ITEM NO.	PART NO.	DESCRIPTION OR SIZE	QTY. REQ.
PARTS LIST			
UNLESS OTHERWISE SPECIFIED		ORIGINATOR	A. MATYUSHIN 3-88
FRACTIONS	DECIMALS	ANGLES	DRAWN A. MATYUSHIN 3-88
±	±	±	CHECKED
1. BREAK ALL SHARP EDGES 1/64 MAX.		APPROVED	
2. DO NOT SCALE DWG.		USED ON	
3. DIMENSIONING IN ACCORD WITH ANSI Y14.5 STD.		MATERIAL-	
✓ MAX. ALL MACHINED SURFACES			
FERMI NATIONAL ACCELERATOR LABORATORY UNITED STATES DEPARTMENT OF ENERGY			
ACCELERATOR CONTROLS DIGITAL FUNCTION GENERATOR CAMAC 372 SCHEMATIC RF-127			
SCALE	FILMED	DRAWING NUMBER	REV.
		0812-ED-218425	SHEET 1 OF 2

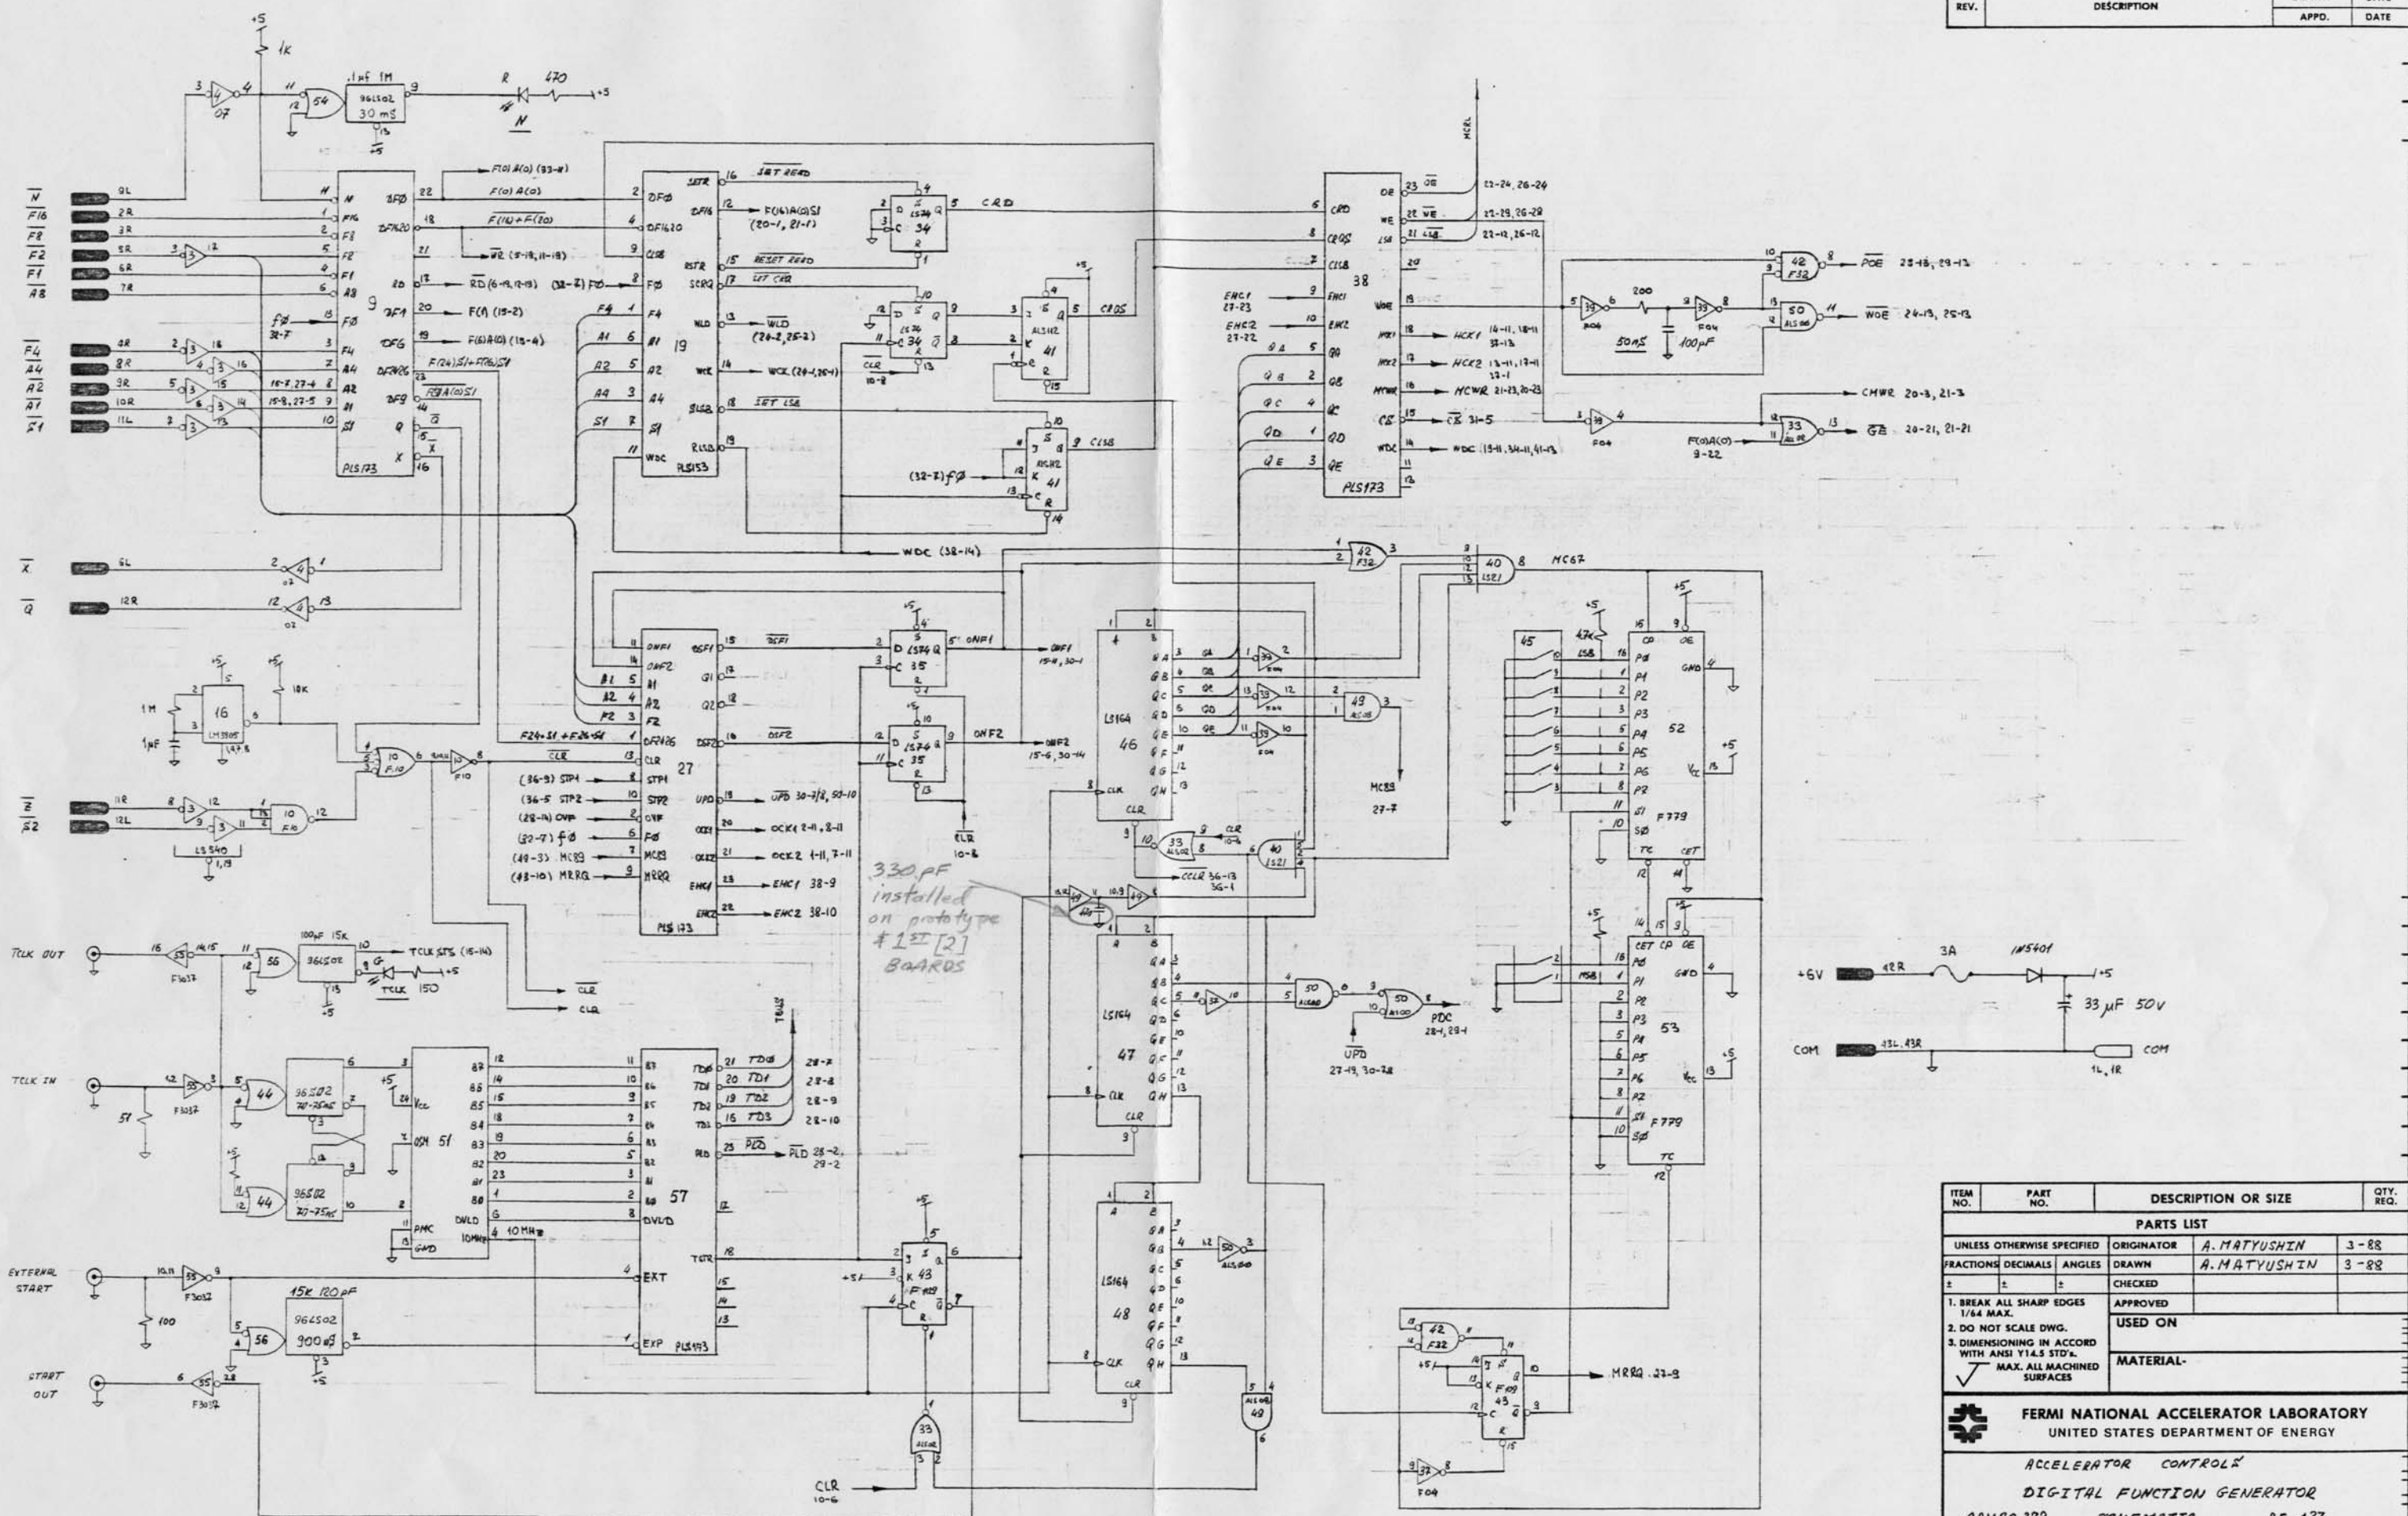
330 pF installed on prototype #121 [2] BOARDS
